MILTON MUNICIPAL UTILITY COMMISSION  
CABELL COUNTY, WEST VIRGINIA

CONTRACT #1 – MORRIS MEMORIAL SANITARY SEWER EXTENSION

ADDENDUM #1

THRASHER PROJECT #020-1526

**TYPICAL ACCESS ROAD DETAIL**  
**SECTION VIEW**  
NOT TO SCALE

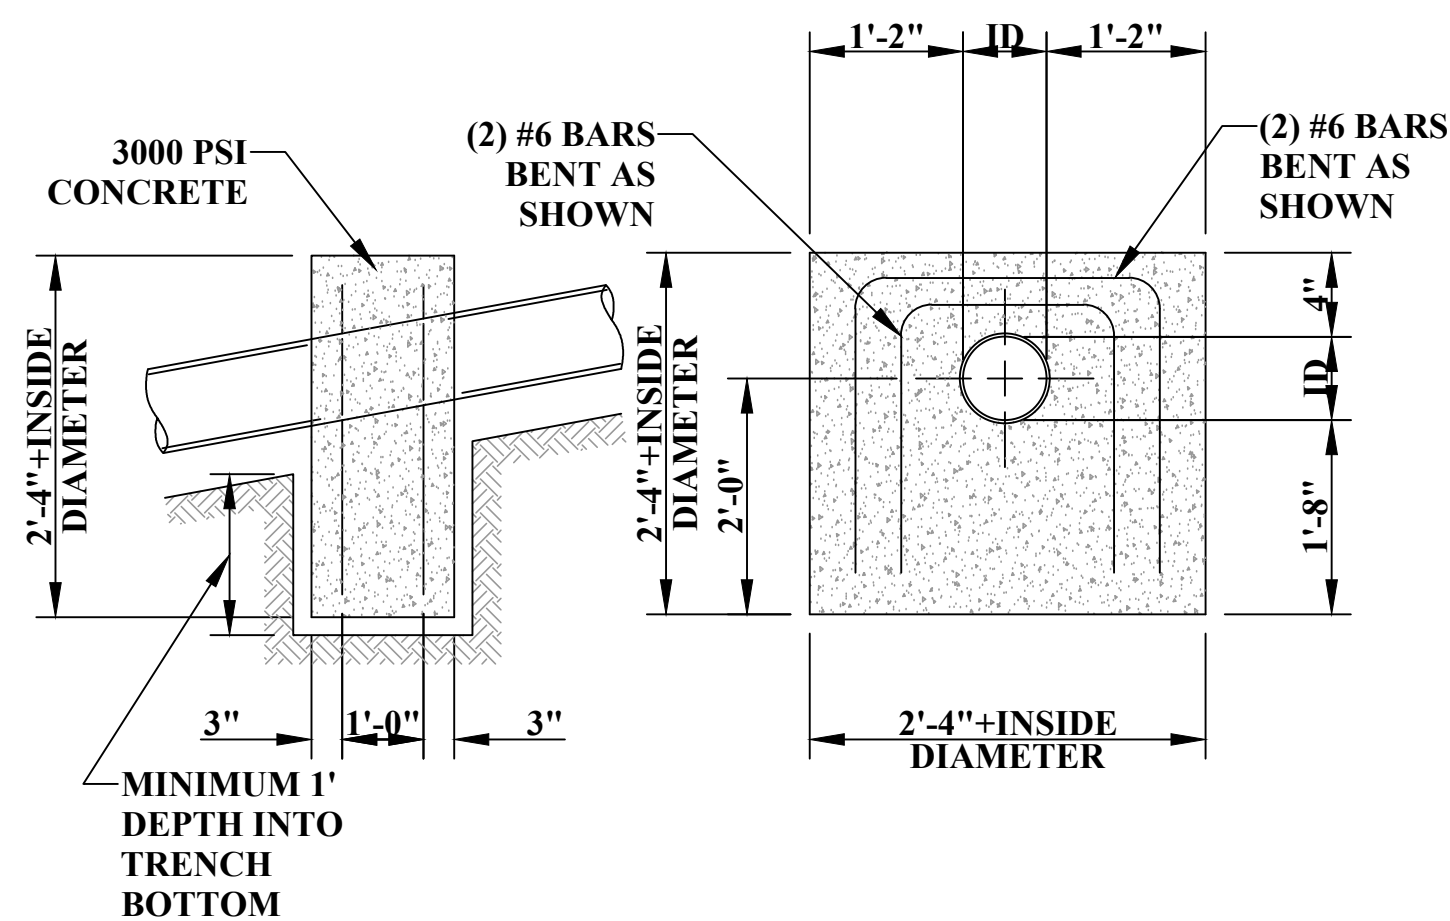
NO.	BY	DATE	DESCRIPTION
1	KMP	1/2022	ADDENDUM 1 - ADDED TYPICAL ACCESS ROAD DETAIL

SHEET No.  
**E-2**

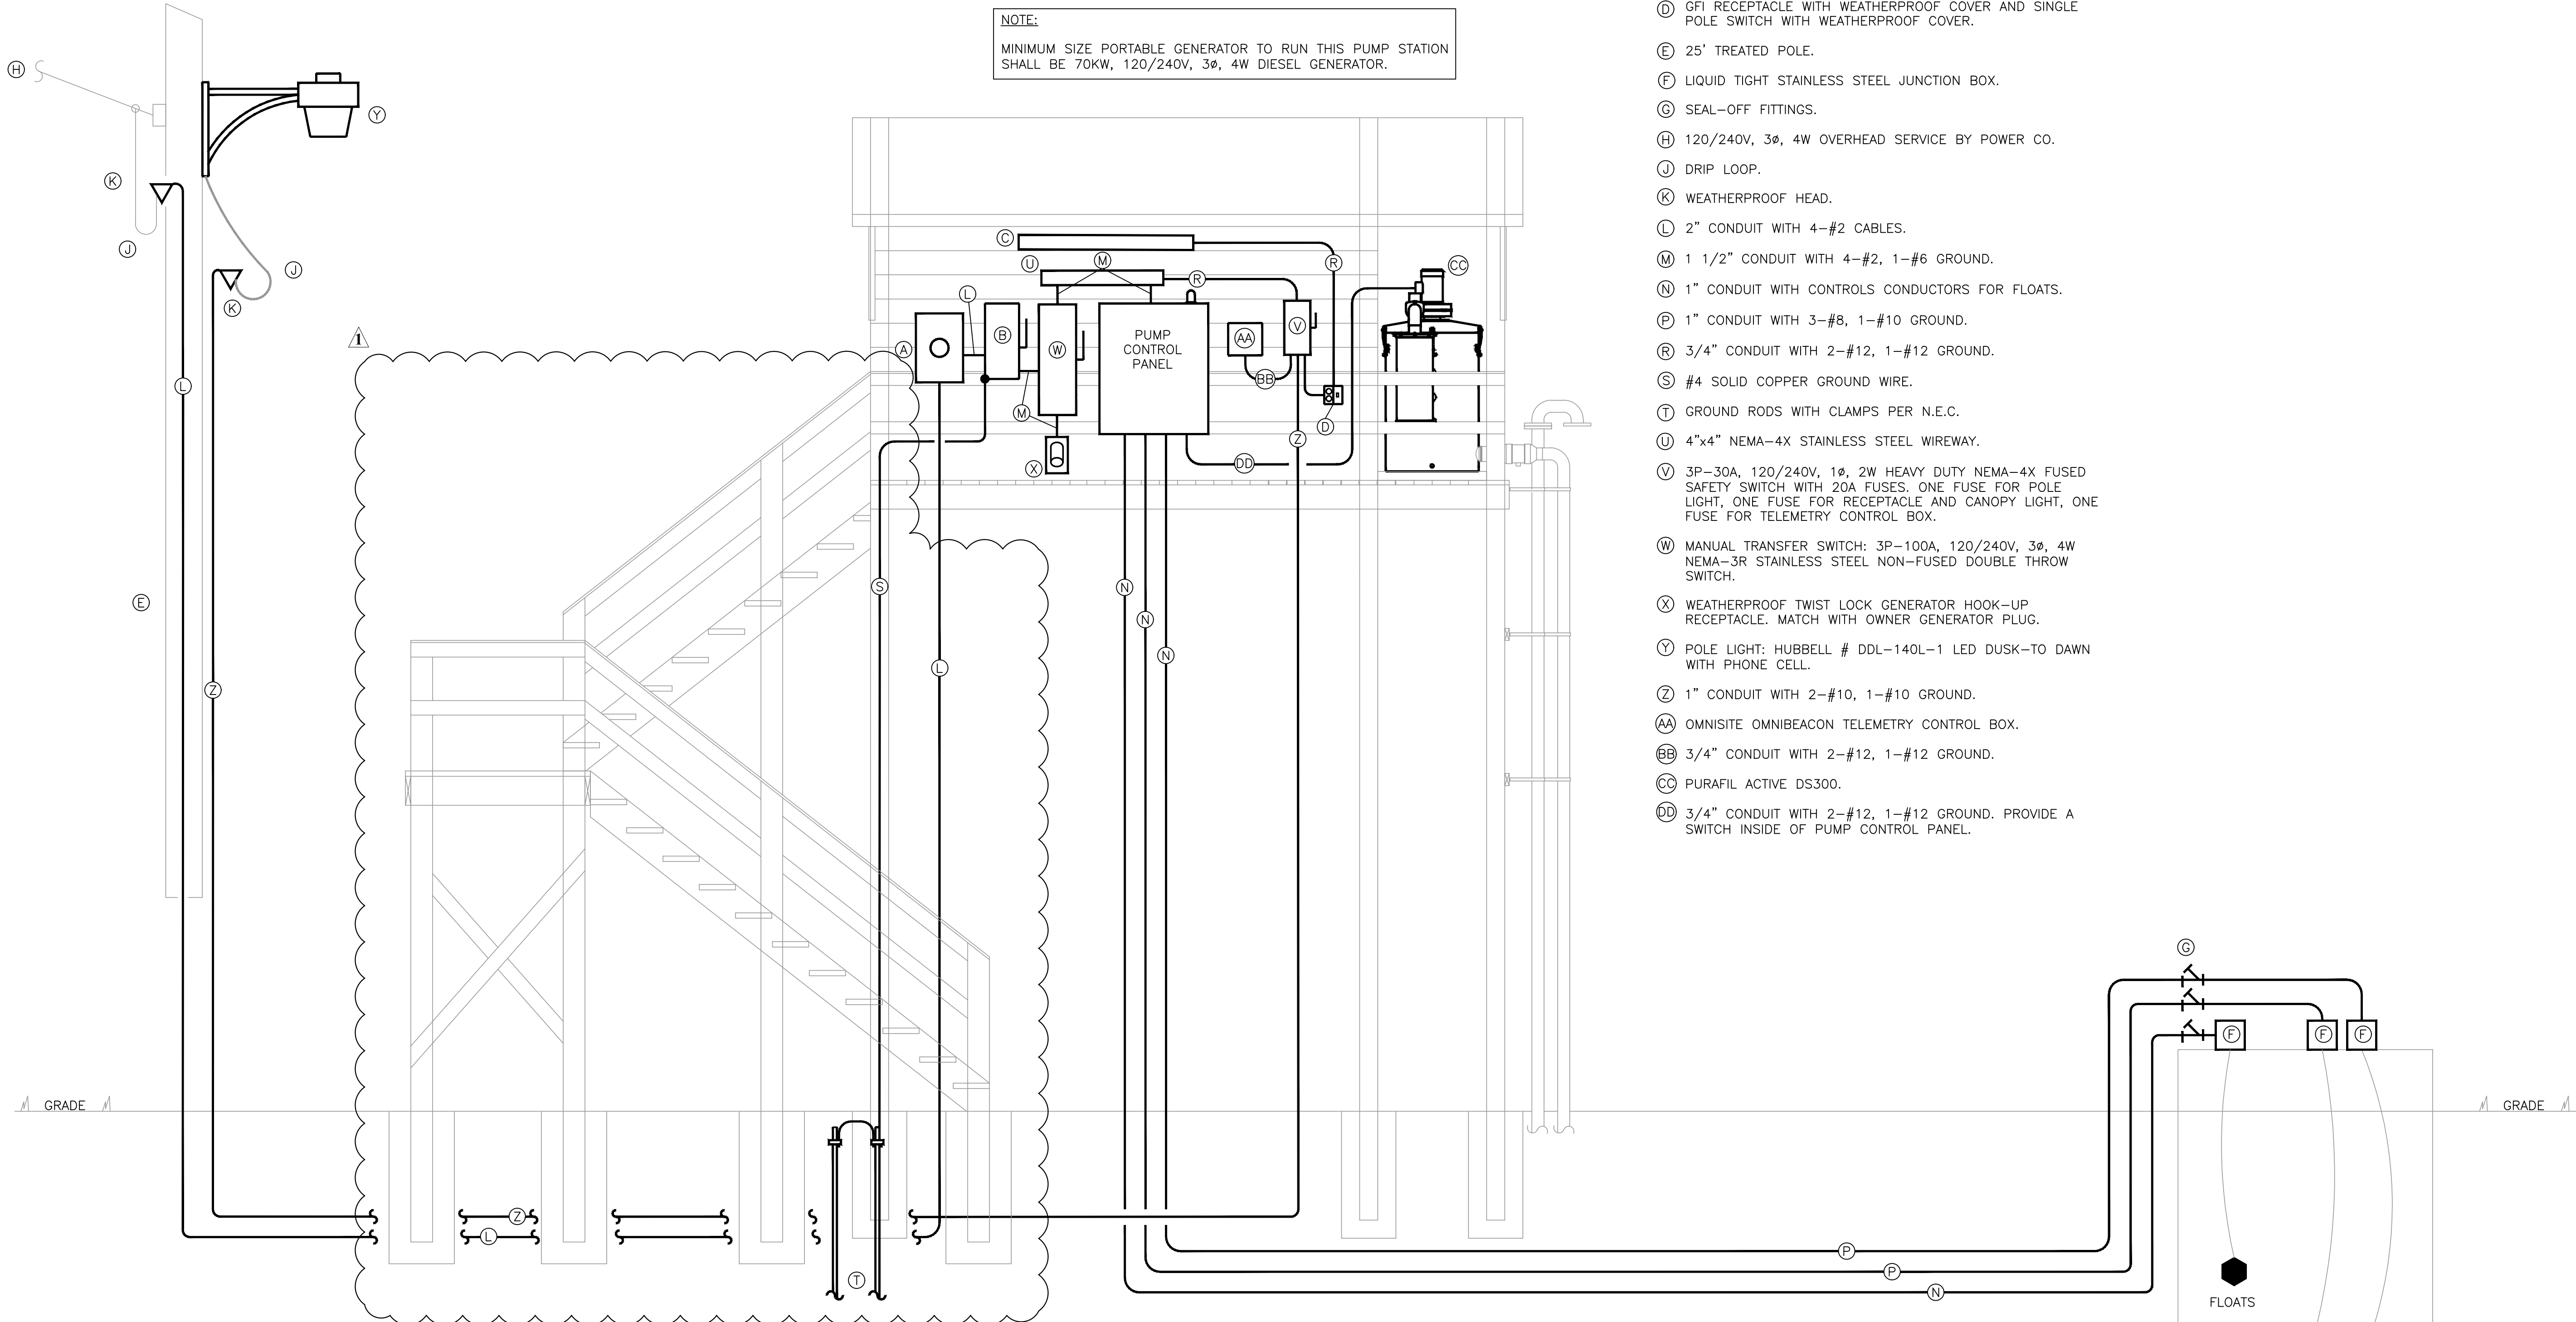
NO.	BY	DATE	DESCRIPTION
1	KMP	1/2022	ADDENDUM 1 - ADDED REVISED STAIR ACCESS
